UNITED STATES PATENT AND TRADEMARK OFFICE

10/789,365

Office Action Summary	Application No. 10/789,365	Applicant(s) DENOTH ET AL.	
	Examiner QUYNH-NHU H. VU	Art Unit 3763

DETAILED ACTION

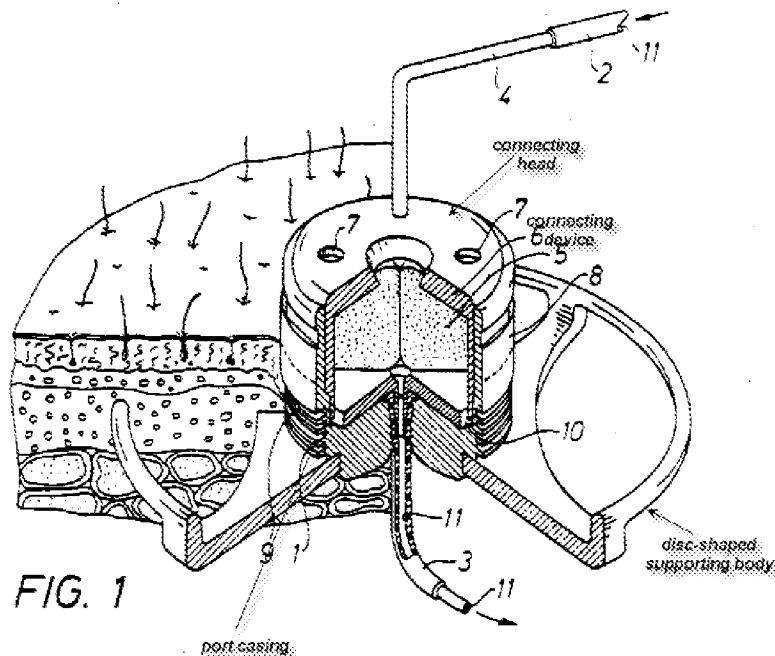
Claims 35-36 are rejected under 35 U.S.C. 102(b) as being anticipated by Svensson et al. (US 5,098,397).

As best as understood, Svensson discloses a port system, comprising:

an implantable first fluid guiding system comprising a disc-shaped supporting body;

an external second fluid guiding system 4 with a connecting head at one end;

a percutaneously implantable port for establishing a fluid connection between said fluid guiding systems, said port comprising a port casing 8, which forms a first connecting element;

and a connecting device which comprises a second connecting element on an upper side of the connecting device;

wherein said connecting head is fastened to said port casing by a releasable fastening engagement of said connecting elements;

wherein the connecting head comprises a connecting cannula 3 and said connecting cannula and at least one connector region of the first fluid guiding system, guided into the port casing, exhibit the same flow cross-section, in order to avoid or at least minimize turbulence in the fluid;

wherein the first fluid guiding system feeds in or into the port casing, flush with said connecting cannula, in order to avoid or at least minimize turbulence in the fluid at a transition between the connecting cannula and the first fluid guiding system.
